REMARKS

Fig. 2

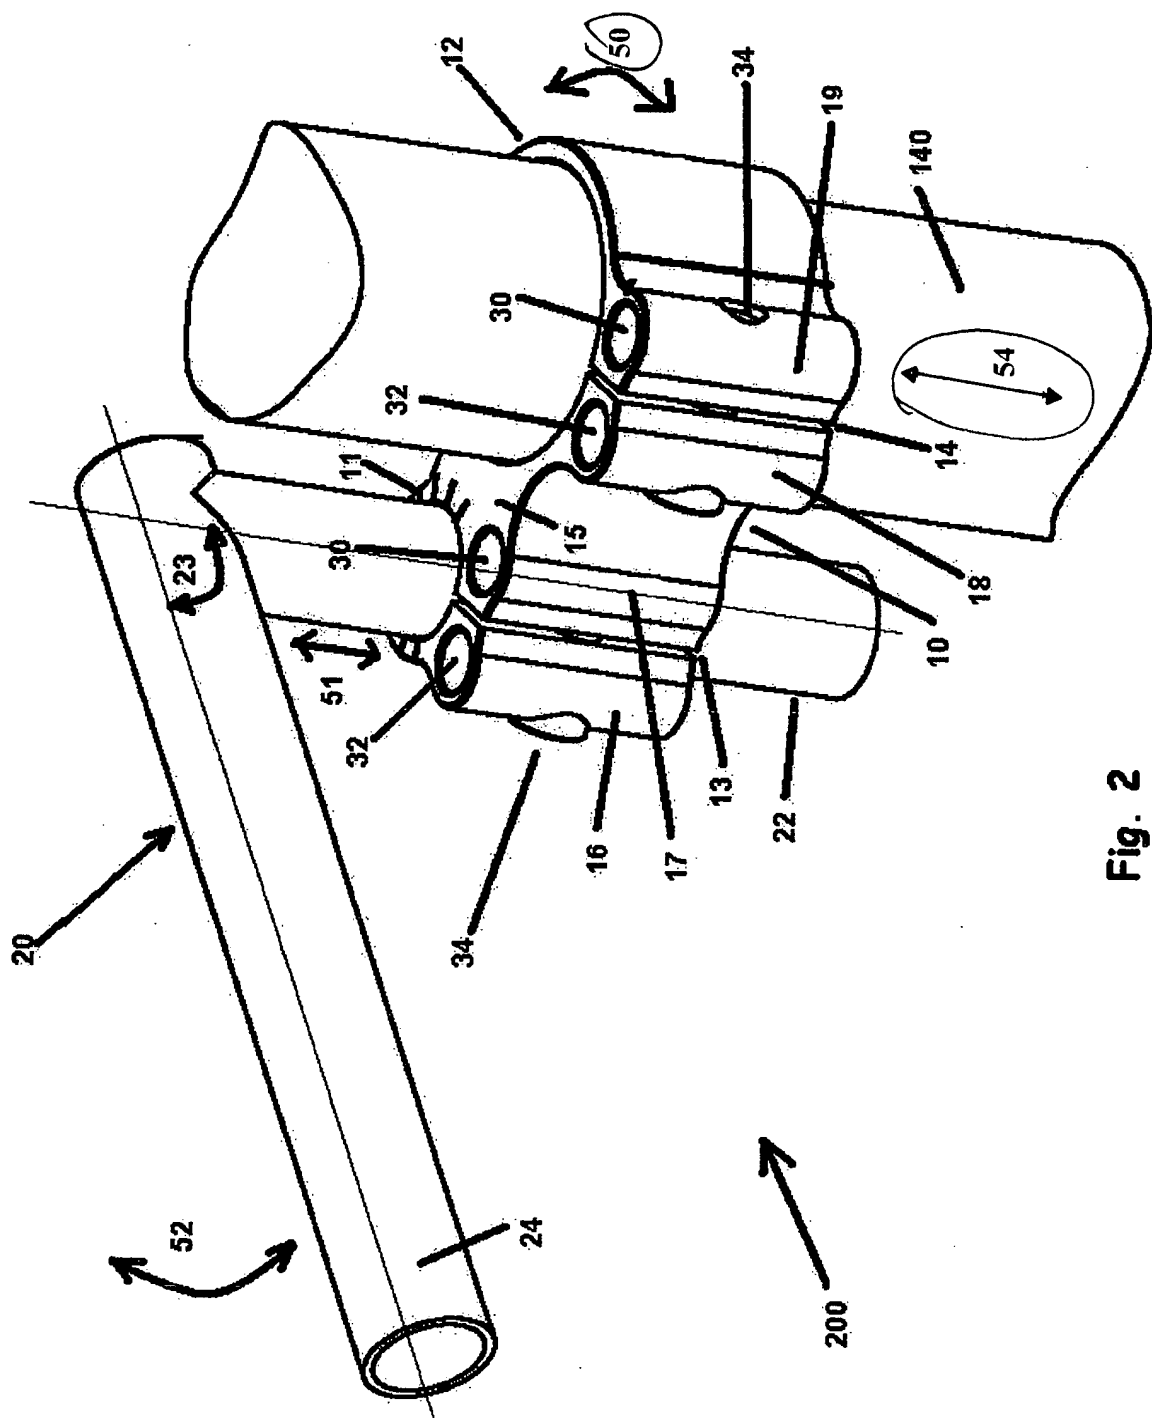
Figure 2 has the reference number 50 for clockwise turning of the clamp on the fork tubes, which should be reference number 54. Reference number 50 and direction arrows for vertical adjustment of the clamp on the fork tubes was added. The specification at page 7 lines 1-5 explain the reference numbers, therefore no new matter is believed to have been added by the changes to the drawings.
